MEETING DATE: AUGUST 11, 2020
AGENDA ITEM SECTION: PUBLIC HEARING
AGENDA ITEM NO. : 2
AGENDA ITEM: CONTINUATION OF PUBLIC HEARING FOR REVIEW OF THE APPLICATION OF 41 CEDAR STREET
ITEM BACKUP DOCUMENTATION: 1. LETTER DATED AUGUST 3, 2020 FROM MS. LINDA WHITEHEAD/ATTORNEY TO MAYOR VINCENT ROSSILLO AND THE BOARD OF TRUSTEES 2. 41 CEDAR STREET - PLANS

Re: Cedar Commons – 41 Cedar Street

CEDAR COMMONS

BOT REVISIONS - 8-3-20

DESIGN B CEDAR COMMONS ZONING DATA / FLOOR AREA CALCULATIONS

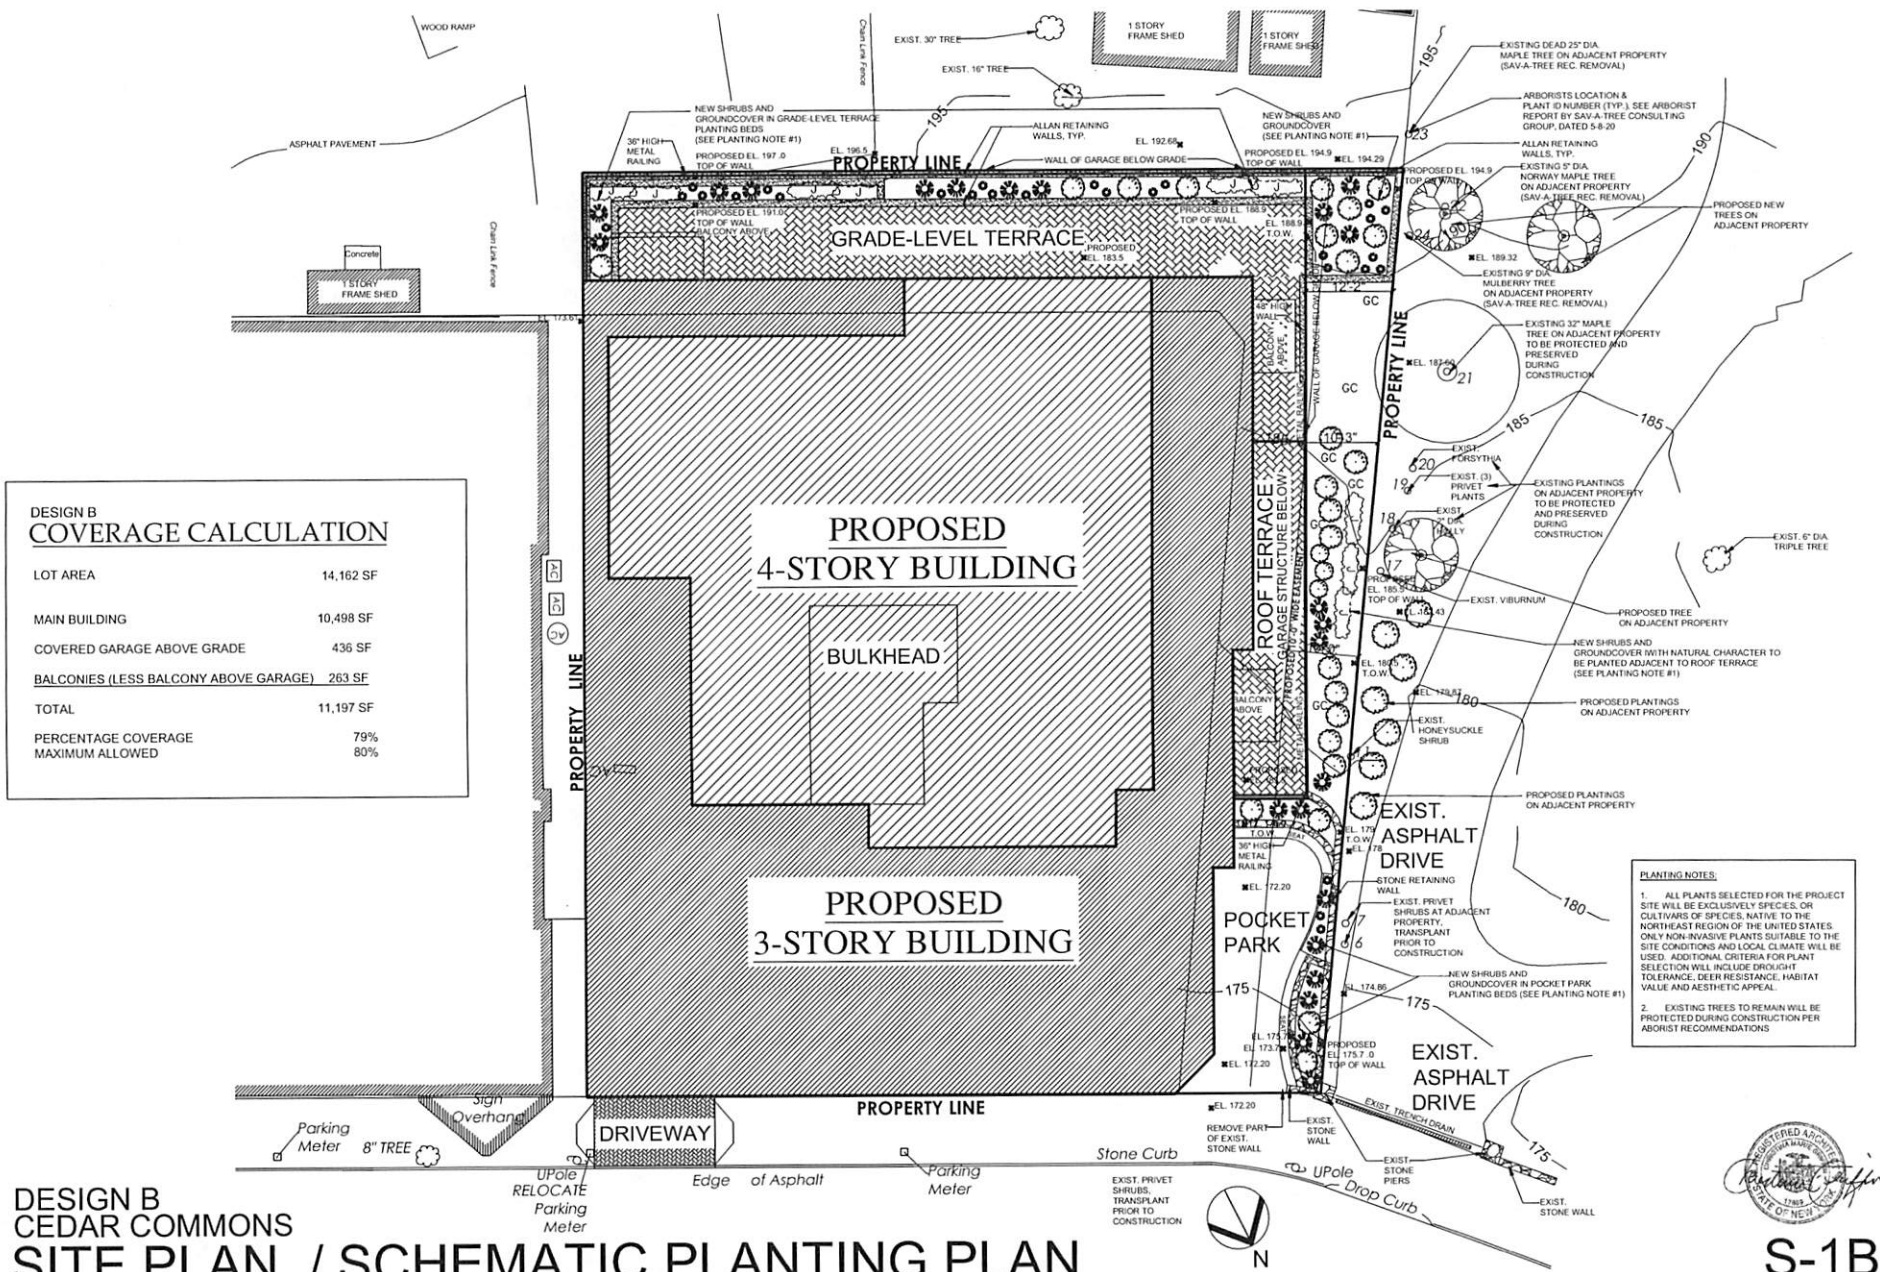
- 2-Bedroom affordable units are now 80% of area of the average of the market rate units as required by the Code, and calculations have been added to the plans.
- The fourth floor has been reduced to a floor area which is 50% of third floor below.
- The bulkhead has been reduced in size to 10% of the fourth-floor roof area.
- The overall height of Building has been reduced to 45'0" to meet the maximum required by Code.

NUMBER OF AFFORDABLE UNITS PROVIDED: (2) 2-BEDROOM UNITS (1) STUDIO			
REQUIRED AREA OF AFFORDABLE UNITS AFFORDABLE UNITS REQUIRED TO BE MIN. 80% AREA OF COMPARABLE MARKET RATE UNIT 80% OF AVERAGE SIZE MARKET RATE UNIT (1,494 SF) = 1,195 SF

UNIT AREA CALCULATIONS - DESIGN B	
SECOND FLOOR	UNIT 9 2-bedroom/2.5 bath 1,789 SF + 102 SF BALCONY
UNIT 1 2-bedroom/2-bath Affordable Unit #1 1,123 SF + 227 SF BALCONY 1,123 + 1/3 BALCONY ALLOWANCE (75 SF) = 1,198 SF (1,195 SF MIN. REQUIRED)	UNIT 10 2-bedroom/2.5 bath 1,749 SF + 62 SF BALCONY
UNIT 2 Studio Affordable Unit #2 493 SF + 83 SF BALCONY (450 SF MIN REQUIRED)	UNIT 11 2-bedroom/2.5 bath 1,400 SF 62 SF BALCONY
UNIT 3 2-bedroom/2 bath (CORNER UNIT #3 AT REAR/ALLEY)	UNIT 12 2-bedroom/2.5 bath 1,534 SF
UNIT 4 2-bedroom/2.5 bath 1,519 SF + 759 SF TERRACE	UNIT 13 2-bedroom/2.5 bath 1,470 SF
UNIT 5 2-bedroom/2.5 bath 1,549 SF + 346 SF TERRACE	FOURTH FLOOR
UNIT 6 2-bedroom/2.5 bath 1,465 SF	UNIT 14 2-bedroom/2.5 bath 1,436 SF + 753 SF ROOF DECK + PRIVATE ROOF DECK AT ROOF ABOVE
UNIT 7 2-bedroom/2.5 bath 1,470 SF	UNIT 15 2-bedroom/2.5 bath 1,331 SF + 489 SF ROOF DECK + PRIVATE ROOF DECK AT ROOF ABOVE

SECTION THROUGH SITE

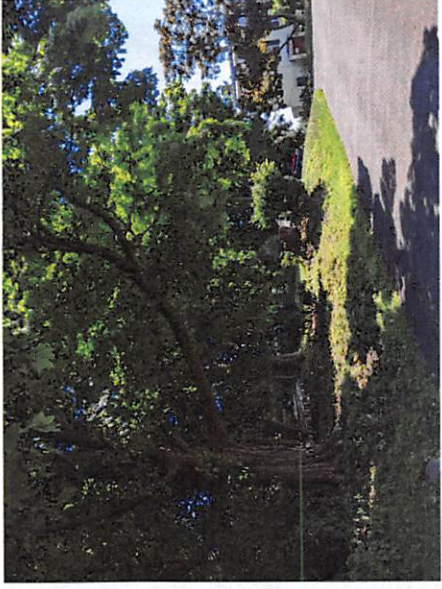
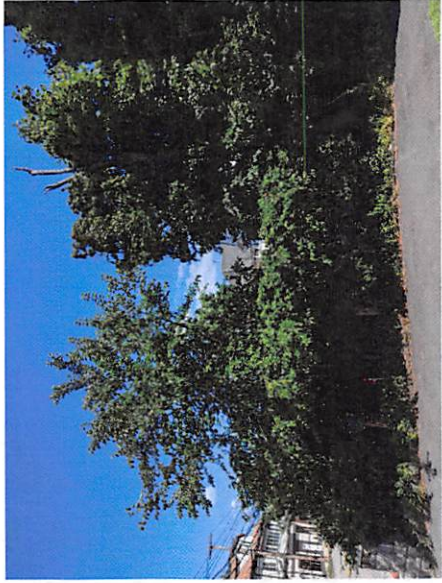
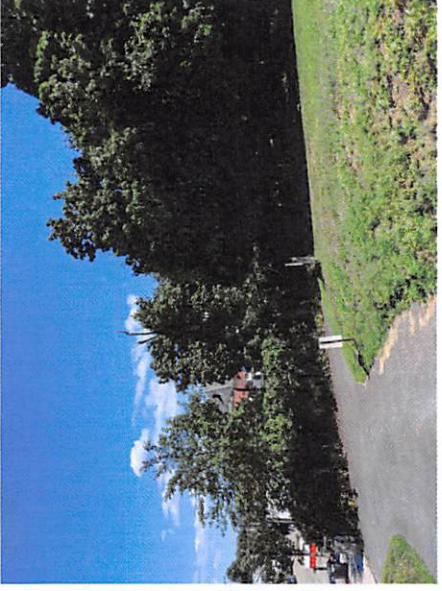
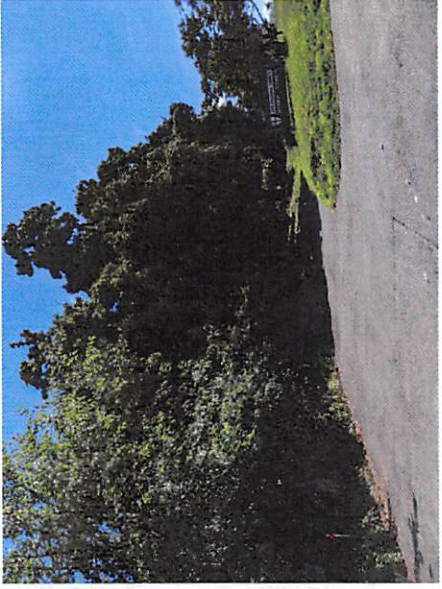
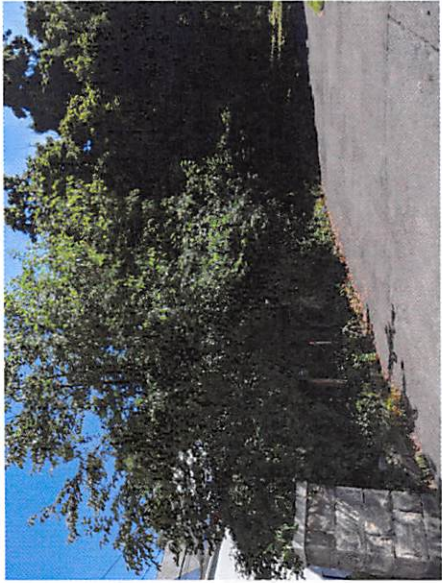
We have also provided a section across the South Presbyterian Church property to the site. As was discussed, the top two floors at the rear of the building will be visible from the parking lot at South Presbyterian Church. The existing building is also visible from this location.
